**Comanche Peak Nuclear Power Plant, Units 3 & 4**  
**COL Application**  
**Part 3 - Environmental Report**

RCOL2\_02.0  
4.12-12 S01

Figure 2.3-27 ~~March-2007~~ Potentiometric Surface Maps ~~(A-Wells)~~ (Sheet 2 of 46)

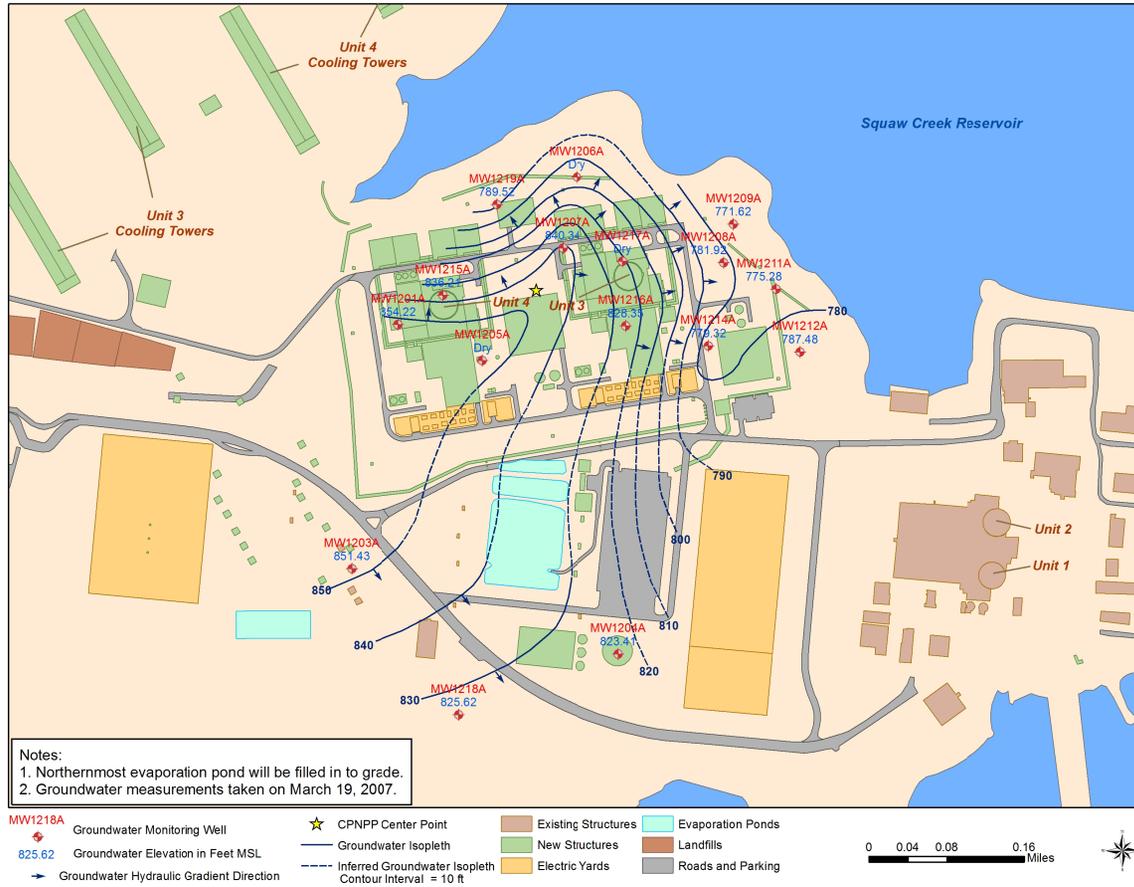
Representative potentiometric surface maps for the initial four quarters of gauging activities (2006-2007) and the final gauging event (December 5, 2012) are presented in Figure 2.3-27, Sheets 1 through 6. These potentiometric surface maps show that the general shallow (A-zone) groundwater movement in the vicinity of CPNPP Units 3 and 4 generally mimics the surface topography except in the filled swales, where groundwater drains rapidly to the elevation of SCR. On the northern portion of the peninsula, a northerly flow toward SCR is observed, and a southerly flow toward the Safe Shutdown Impoundment is observed on the south side of the site peninsula. West of the proposed Unit 4, regolith groundwater flow is interpreted to be in the direction of an unfilled swale (proposed western stormwater retention basin location). No permanent streams are present on site, and no surface discharge of groundwater to the land surface has been observed.
